PROPOSED CHRISTMAS FARM, LAND TO THE SOUTH OF LLAY ROAD, CEFN-Y-BEDD, WREXHAM

PLANNING APPLICATION REFERENCE P/2022/0681

**ENCLOSURE 2 – DRAWING NO. 3034-01-D02A: PROPOSED SITE ACCESS
ARRANGEMENTS AND VISIBILITY SPLAYS**

ENCLOSURE 3 - DRAWING NO. 3034-01-ATR01A: SWEPT PATH ANALYSIS

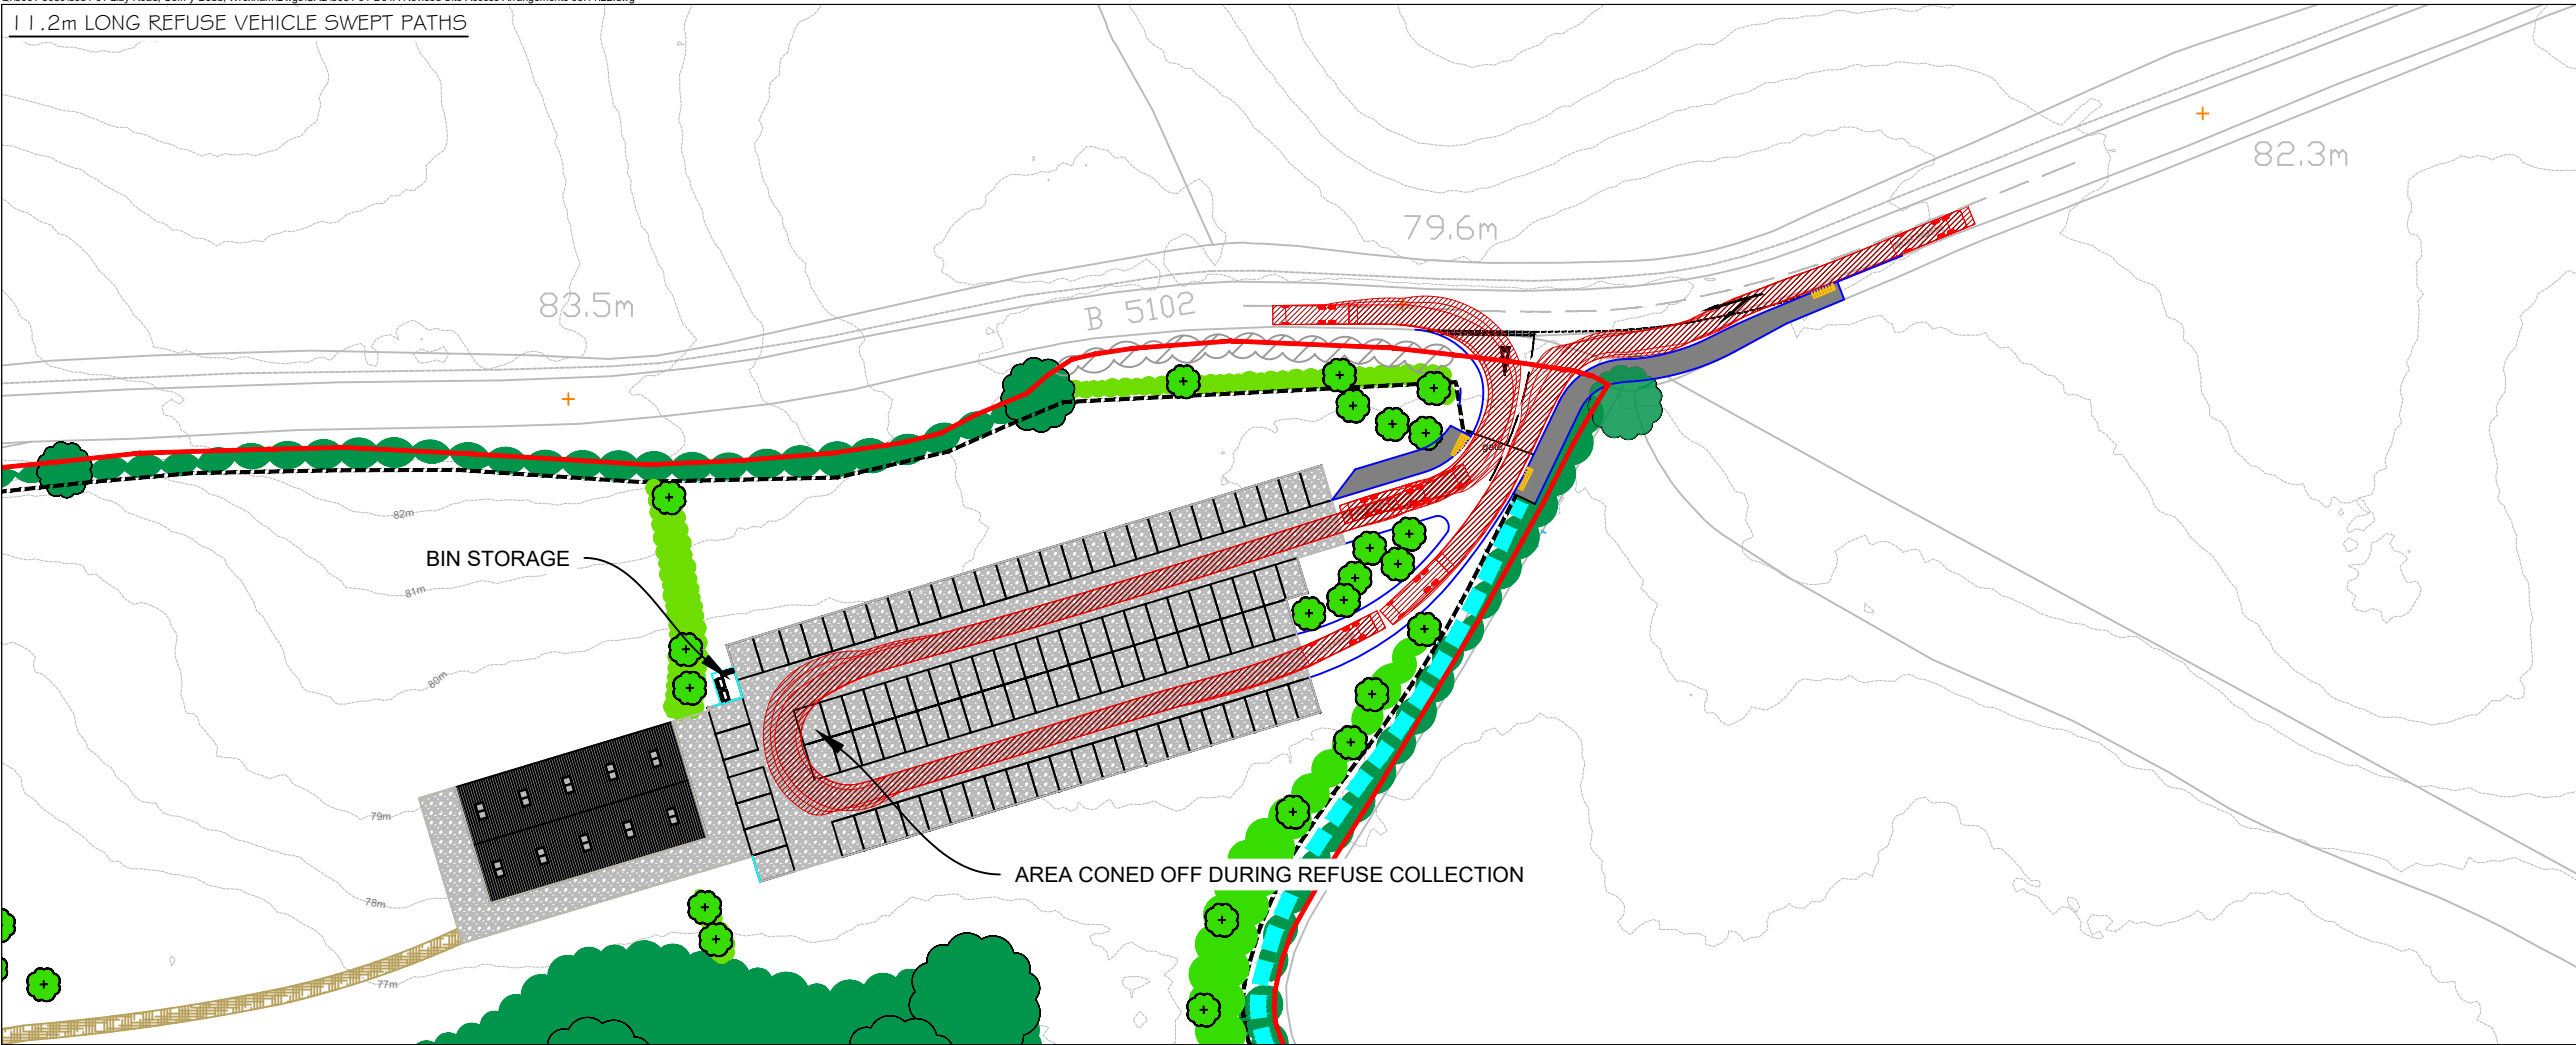
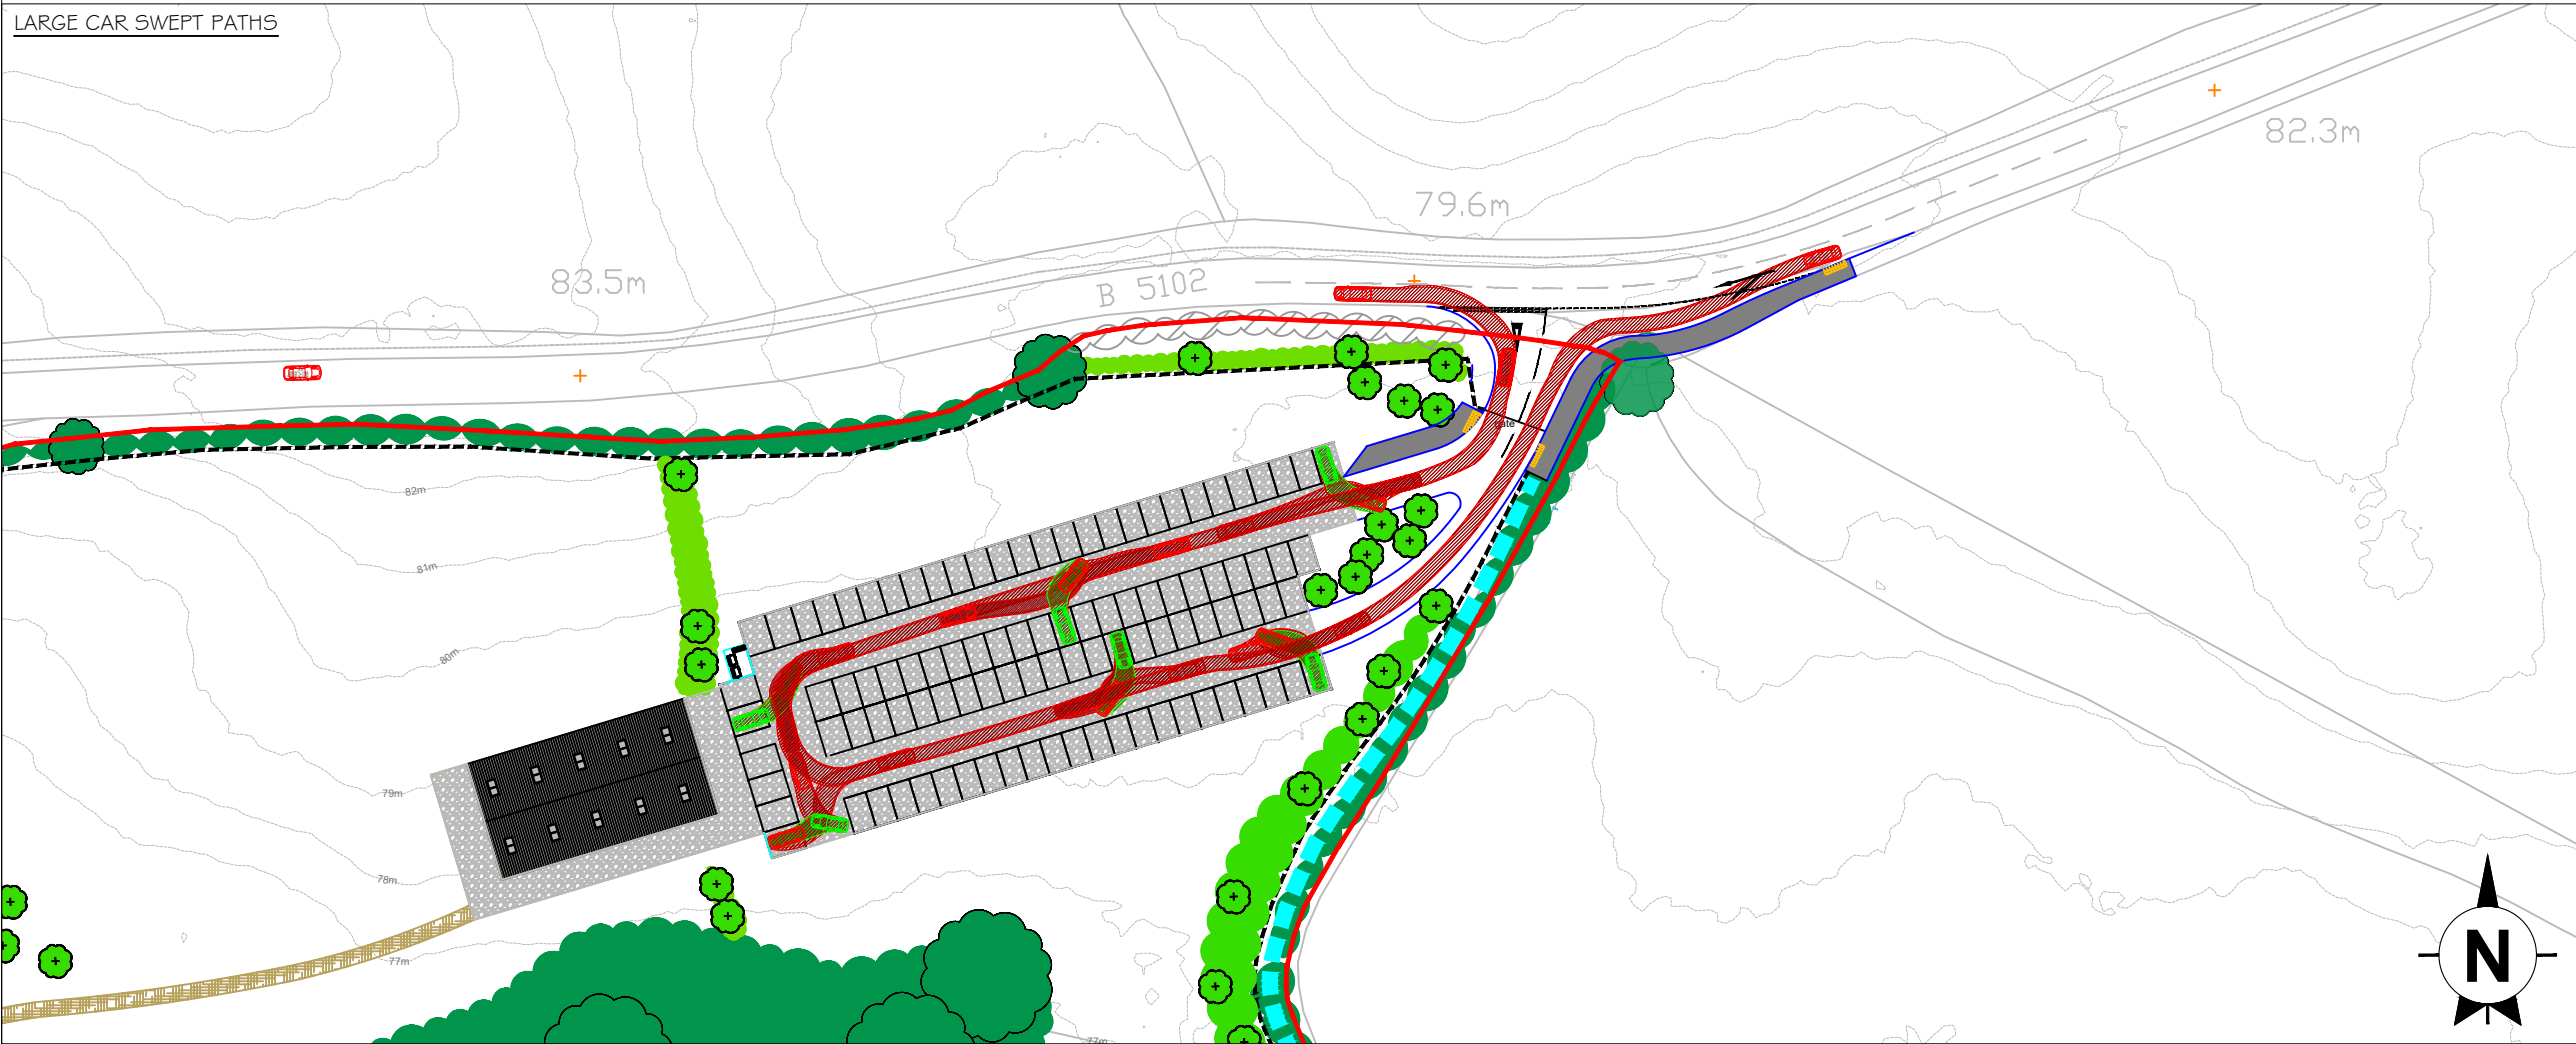
Comment 7 “Details of where refuse / recycling is to be collected from and facilities proposed will need to be provided. I would recommend that the applicant liaises with our Waste Strategy Officer (Catherine Golightly) on Tel: 01978 729693.”

A swept path analysis would need to be undertaken for refuse vehicles with a length of 11.2m.

Refuse collection will be conducted by a private contractor. The proposed refuse collection strategy is shown on **Drawing No. 3034-01-ATR01A (enclosure 3)**. The drawing demonstrates that it will be possible for an 11.2m long refuse vehicle to access and manoeuvre within the site in order to reach the proposed bin storage area satisfactorily. During refuse collection an area of the proposed hardstanding will be coned off in order to secure the necessary manoeuvring space for the refuse vehicle to manoeuvre around the site in a forward gear, as shown on **Drawing No. 3034-01-ATR01A**.

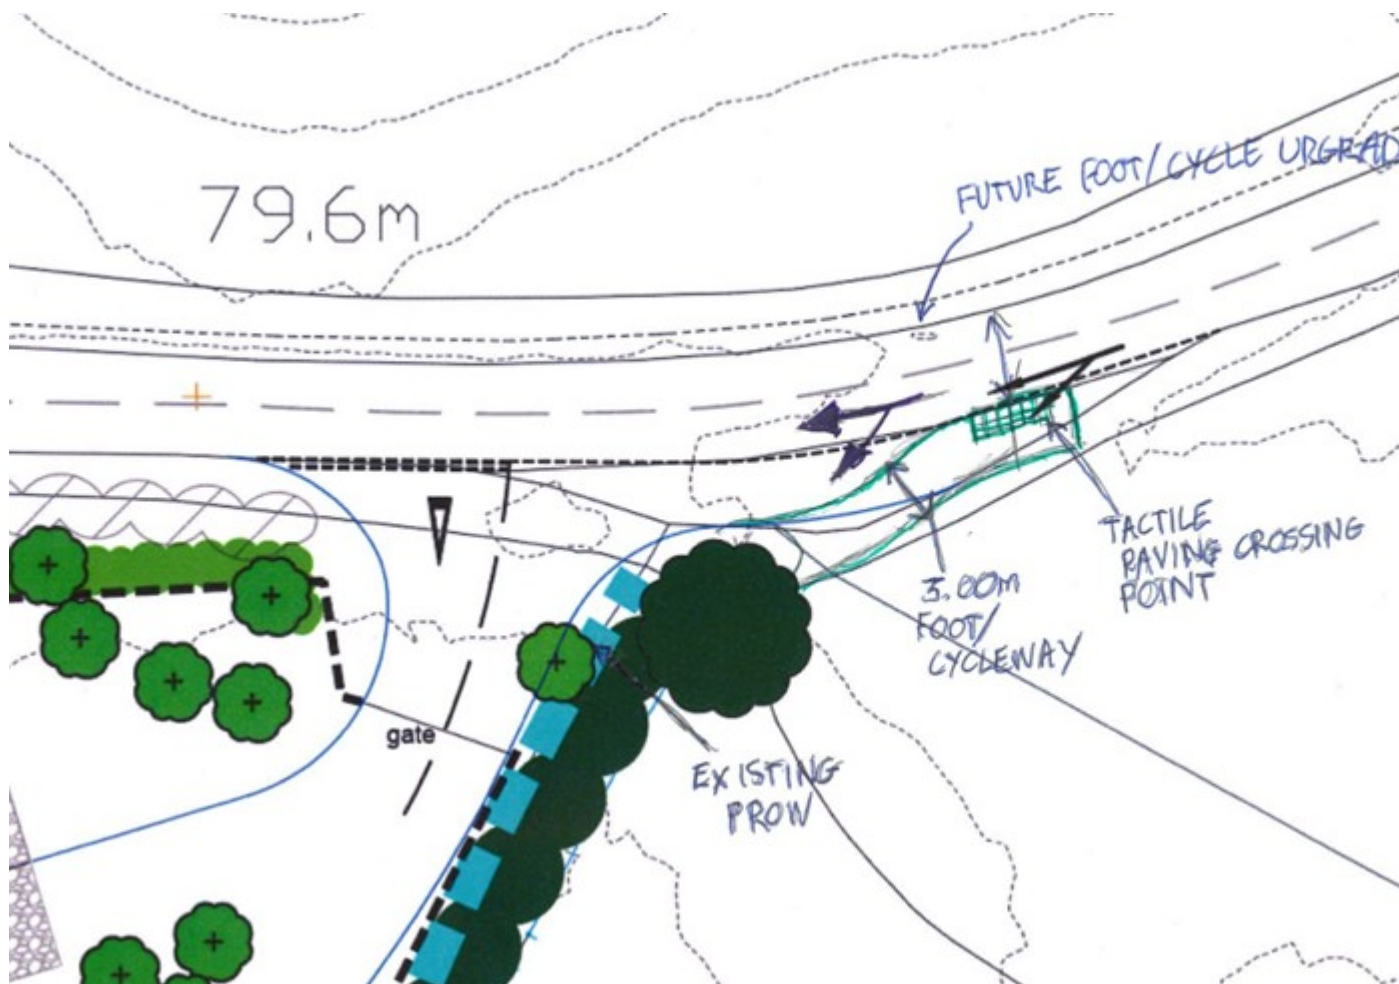
To my mind the proposed crossing would look something like the sketched arrangement below:

Please could you confirm that this is what you had in mind and that I have summarised our call correctly?

There no designs in place as of yet for either side of the road the info I sent on is to aide you should you be inclined to upgrade the footway and allow people the opportunity to access your site by means other than cars, any kind of crossing and entrance would obviously need to be designed to highways standards and position would take into account road spend and visibility etc.

We would not be required to provide excessive lengths of foot / cycleway on the southern side of Llay road as this would not tie into any surrounding foot / cycle infrastructure. If any future upgrades to active travel for the southern side of Llay Road do come forwards then these would be able to integrate with the proposed foot / cycle crossing point brought forwards by this proposal.

You could only provide shard use paths to the frontage of your site.
